# Access Compliance Report

## Public Rights-of-Way

Intersection ID: 10036434	Main Street: ROXBOROUGH_RD	Cross Street: N/A	Location: SW
ADA ID: ECC1AF89791C	Ramp Type: PerpDiag	Initial Pass/Fail: Fail	Overall Compliance: No
Severity Score: 12.5			
Codes/Mitigation Info/Possible Solution		Field Measurements/Component Compliance

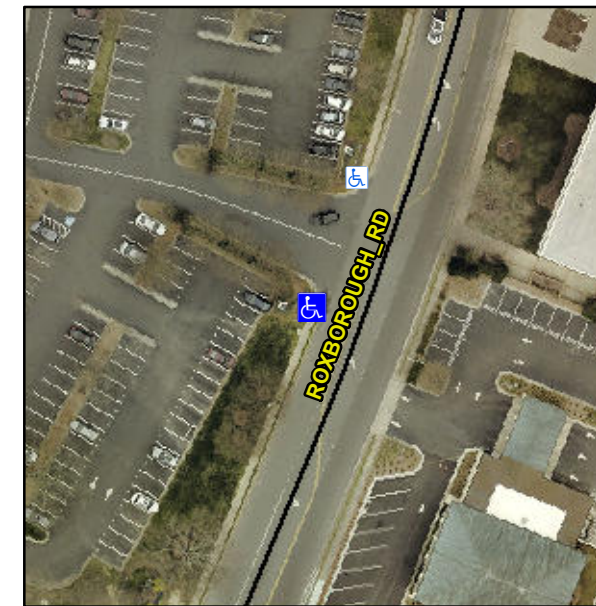
**Not Found, R304.2.2**

Compliance	Description	Data	Compliance	Description	Data
N/A	Ramp Length (in)	47.0	No	Ramp Slope (%)	11.7
Yes	Ramp Width (in)	48.0	Yes	Ramp XSlope (%)	1.3
N/A	Flare Type LT	N/A	N/A	Flare Type RT	N/A
N/A	Flare Slope LT (%)	N/A	N/A	Flare Slope RT (%)	N/A
N/A	Flare Traversable LT?	N/A	N/A	Flare Traversable RT?	N/A
N/A	Landing Length (in)	N/A	N/A	DWS Provided?	N/A
N/A	Landing Width (in)	N/A	N/A	DWS Contrast?	N/A
N/A	Landing Slope (%)	N/A	N/A	DWS Length (in)	N/A
N/A	Landing X Slope (%)	N/A	N/A	DWS Full Width?	N/A
N/A	Landing Curb? (Y/N)	N/A	N/A	DWS Offset (in)	N/A
N/A	Shared Landing?	N/A			
N/A	Gutter Ponding?	N/A	N/A	Gutter Slope (%)	N/A
N/A	Gutter Lip Ht (in)	N/A	N/A	Gutter X Slope (%)	N/A
N/A	Painted X Walk1?	No	N/A	Painted X Walk2?	No
	X Walk 1 Direction	To E		X Walk 2 Direction	To N
N/A	X Walk 1 Width (in)	N/A	N/A	X Walk 2 Width (in)	N/A
	X Walk 1 Slope (%)	6.7		X Walk 2 Slope (%)	0.2
	X Walk 1 X Slope (%)	0.7		X Walk 2 X Slope (%)	0.7

**Remove & Replace Curb Ramp With Two New Directional Ramps or Equivalent.**
